**GLOBAL NUCLEAR FUELS – AMERICAS
REQUEST FOR SUPPLEMENTAL INFORMATION**

Figure 3-1 Inelastic Behavior of Frames with Hinges in Beam Span

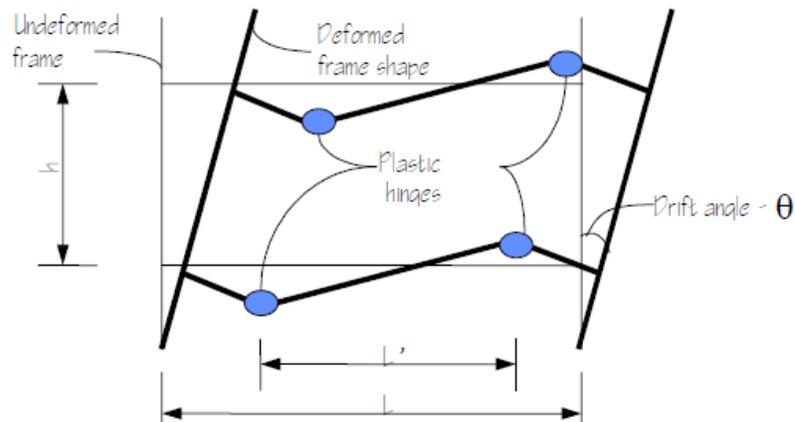
As discussed in Figure 3-1 of FEMA 350¹ provided below, the conditions required for ensuring adequate ductile behavior of frame structures rely on the development of sufficient number of plastic hinges forming in the beams and providing significant energy dissipation. Also, as discussed in the figure, development of plastic hinges in the column is undesirable as this provides relatively little energy dissipation. Although the staff understand that there is a certain level of ductility in the FMO/FMOX structure, the existing report provides little evidence to support the use of a response modification factor consistent with an Intermediate Moment Frame structure.

- a) Provide justification for the assumption that the east-west lateral force resisting frame consisting of columns, roof trusses, and bracing and the north-south lateral force resisting frame consisting of columns and roof trusses meet the member and connection requirements of an Intermediate Moment Frame provided in Section E2 of AISC 341-10 Seismic Provisions for Structural Steel Buildings. The seismic requirements of ASCE 7 require steel structures to meet the requirements of AISC 341 in order to classify the structure as an Intermediate Moment Frame. The

capacity to achieve a specific story drift is only one of the requirements for a lateral force resisting system to be qualified to achieve the ductility under cyclic loading that is expected of Intermediate Moment Frames.
